**Re: Response to Oregon Department of Environmental Quality’s Review
Kinder Morgan Seismic Vulnerability Assessment
Linnton Terminal
Portland, Oregon**

This letter summarizes the response to The Oregon Department of Environmental Quality (ODEQ) comments following review of Kinder Morgan’s Seismic Vulnerability Assessment (SVA) for its Linnton terminal. The following documents comprise the official response:

Table 1
Kinder Morgan Linnton Terminal

Attachment 1
Supplemental Information

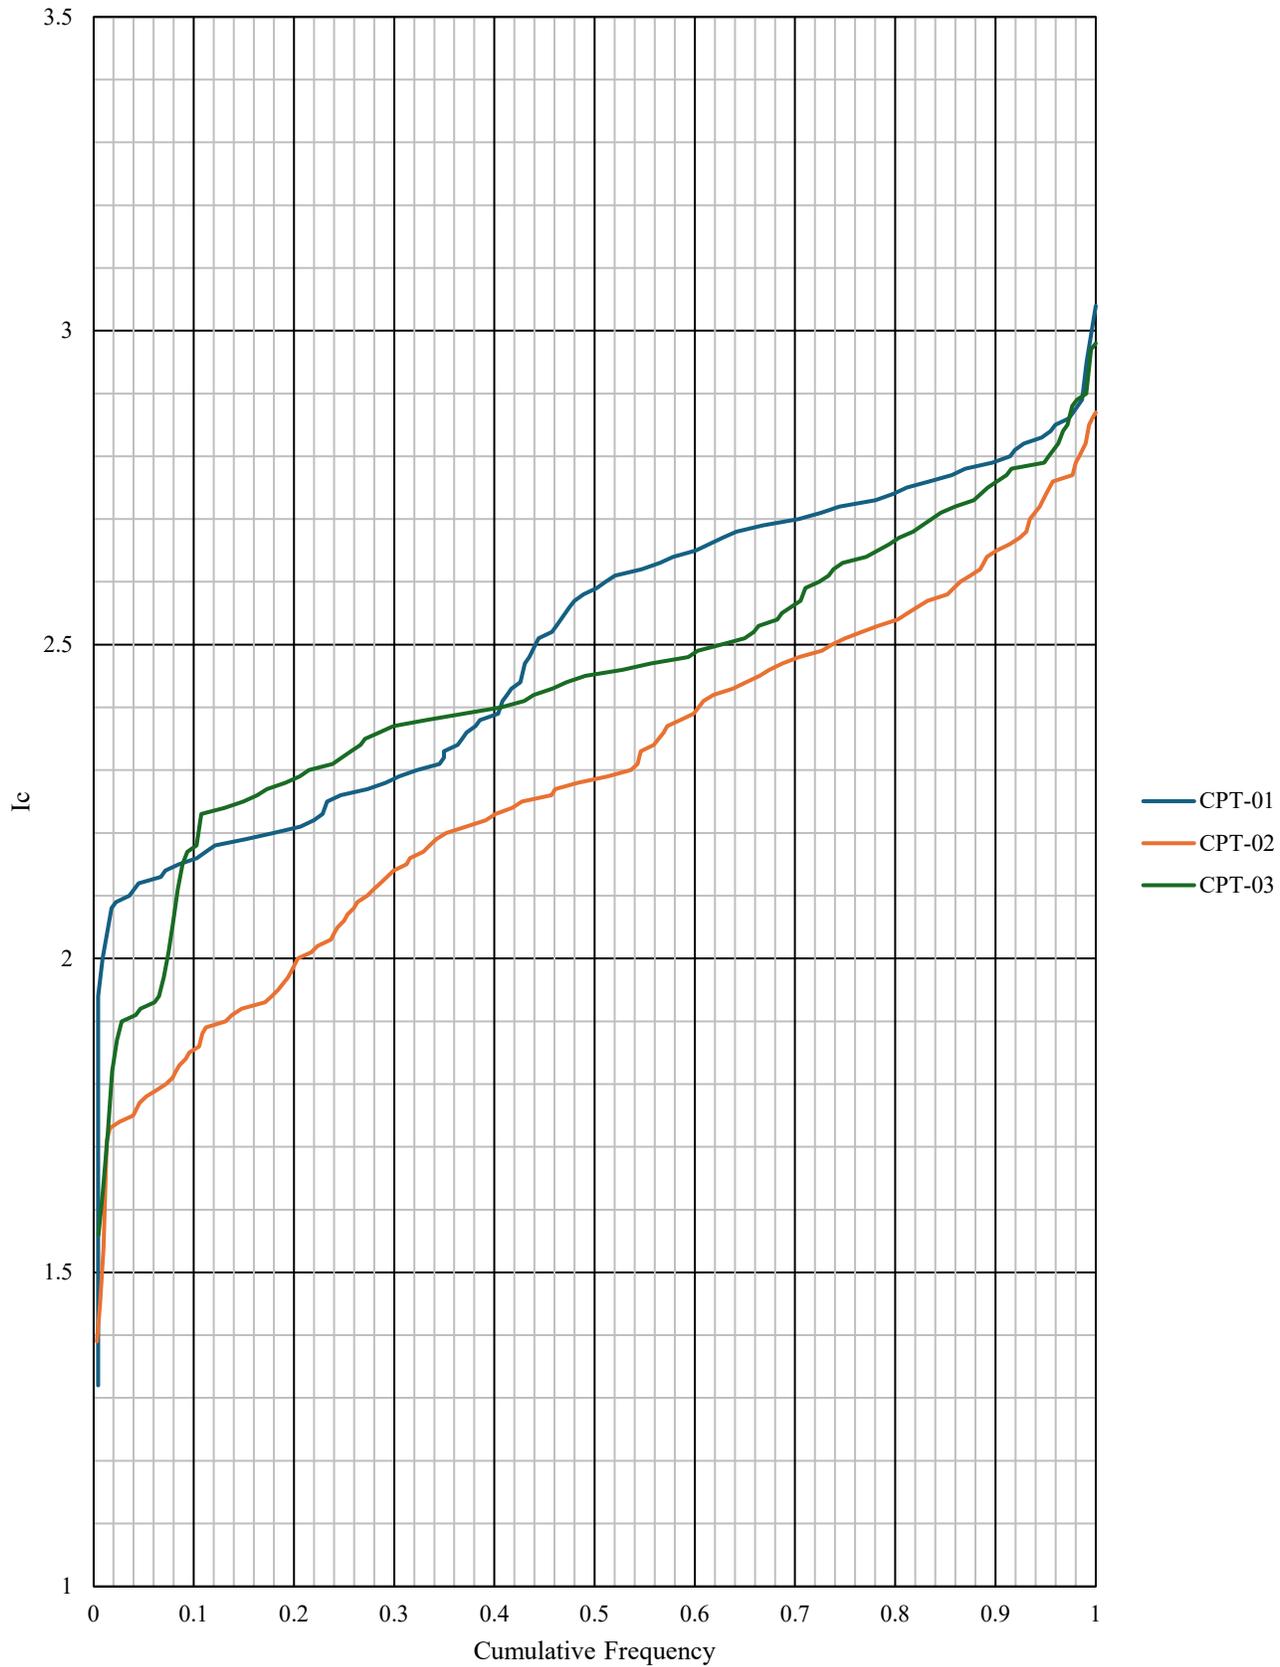
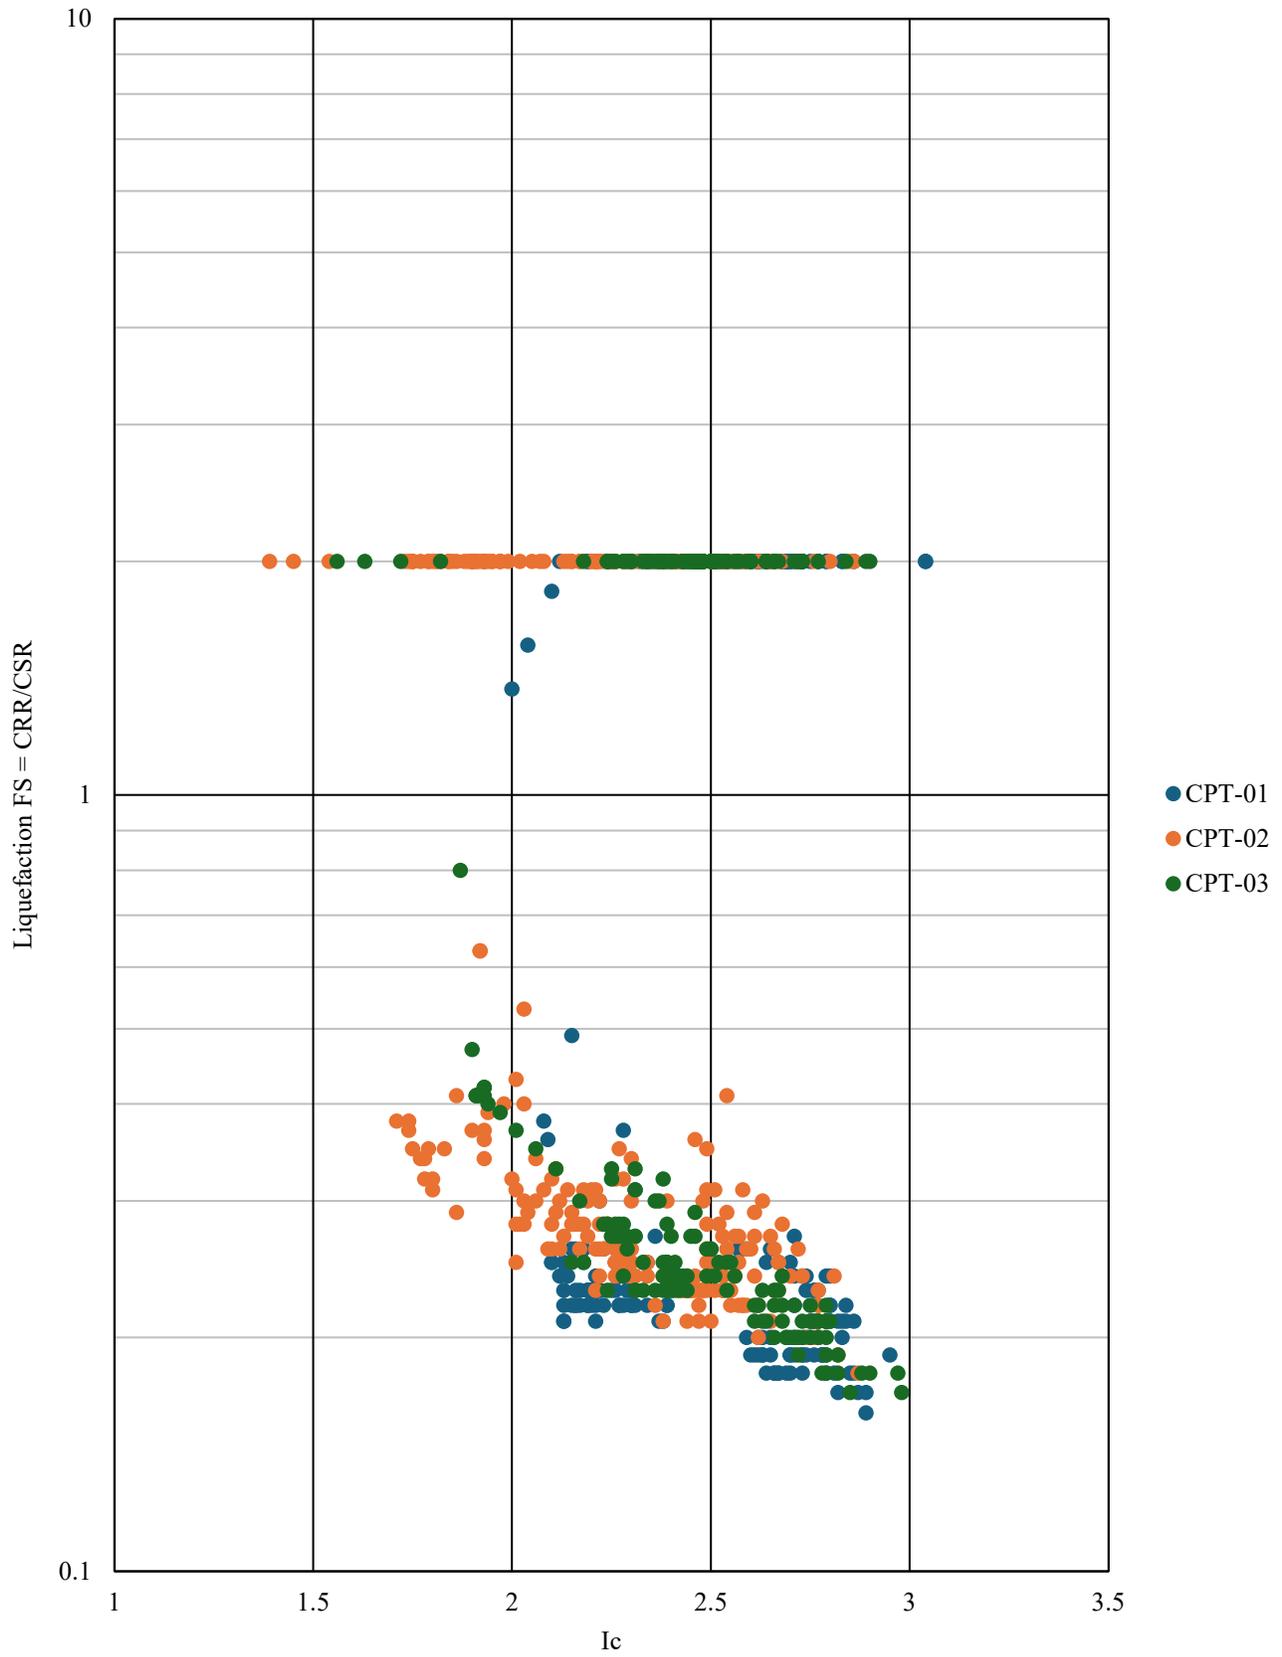
5a	<p>Liquefaction potential in "Sand-Like" Soil and Cyclic Degradation in "Clay-Like" Soil How was cyclic resistance ratio evaluated (simplified or site-specific)? [GEO5]</p>	<p>Simplified. This is addressed in great detail in SVA section 5.1.1.2.2 and Appendix A-3. Supplemental information is provided below:</p> <p>The average $S_{u,r}$ discussed in SVA section 5.1.1.2.2 was computed based on liquefaction FS with a FS cutoff of 1.0 (see comment/response to question 5f for additional discussion on using FS=1.0). This means that all soil layers with FS<1.0 were assigned a residual shear strength based on their CRR (i.e., the sand-like approach), regardless of their I_c. In other words, layers that are clay-like and may only degrade 85 percent or so of their static strength were still assigned a sand-like residual shear strength if they were triggered (i.e., FS <1.0). This is a conservative approximation/simplification.</p> <p>As discussed in section 5.1.1.2.2, CPT soil behavior type I_c was used to determine susceptibility to liquefaction. Specifically, we selected $I_c > 3.0$ as not susceptible to liquefaction. Triggering calculations are performed on all soil layers (i.e., the liquefaction FS is computed for all soil layers) and is not automatically set larger than 2 if not susceptible. Typically, an I_c of 2.6 is used to determine susceptibility (i.e. $I_c < 2.6$ is not susceptible per Robertson and Wride 1998). Our experience with Willamette Silts/Willamette River Alluvium from several sites along NW St. Helens Blvd and Yeon Ave indicates that an I_c of 2.6 is typically an unconservative cutoff. However, we have not observed a strong correlation between plasticity index and I_c for these soils. Therefore, we have selected I_c of 3.0 as the cutoff based on the following justification. First, it represents a more fines-dominant soil behavior type grouping. Second, by using $I_c > 3.0$ as the susceptibility cutoff, we filter out all data with a normalized friction ratio F less than about 2 percent, indicating low likelihood of liquefaction because F is large (Robertson and Wride 1998). Finally, as shown by the cumulative frequency of I_c (see Attachment 1), using I_c of 3.0 excludes less than 1 percent of data from being susceptible to liquefaction. These three points indicate a conservative approach to determining susceptibility and sand-like vs. clay-like behavior. Our opinion is that this approach is suitable for a vulnerability assessment.</p>
